Nat. Hazards Earth Syst. Sci. Discuss., referee comment RC2 https://doi.org/10.5194/nhess-2021-65-RC2, 2021 © Author(s) 2021. This work is distributed under the Creative Commons Attribution 4.0 License.

Comment on nhess-2021-65

Referee comment on "The Cambodian Mekong floodplain under future development plans and climate change" by Alexander J. Horton et al., Nat. Hazards Earth Syst. Sci. Discuss., https://doi.org/10.5194/nhess-2021-65-RC2, 2021

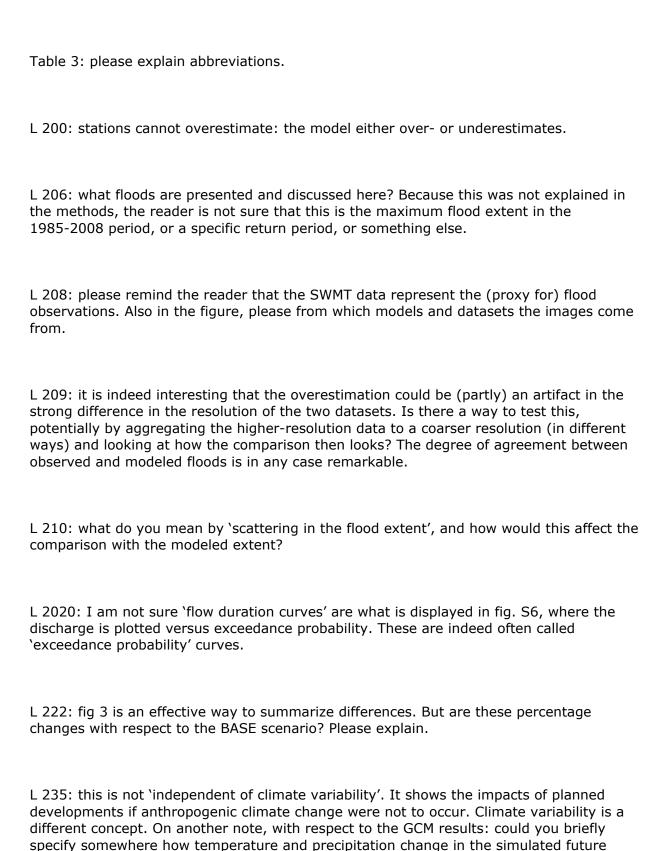
L 173: there is no Pla2020 scenario in table 2.

L 174: are LMB 2020 dams only two, in addition to those of 2007 in scenario BASE? If so, don't mention 'Xayaburi and Don Sahong only', or it will seem like an arbitrary choice to include only two. Further, when describing e.g. scenario Pla2020 just outline the differences from the BASE scenario, without mentioning everything that is included again. Also, clarify how factors like agriculture, land use irrigation change across years 2007, 2020, 2040: what are the sources of these datasets and what drivers and socio-economic scenarios do they presuppose? How are these factors included in the modeling, how are they parametrized?
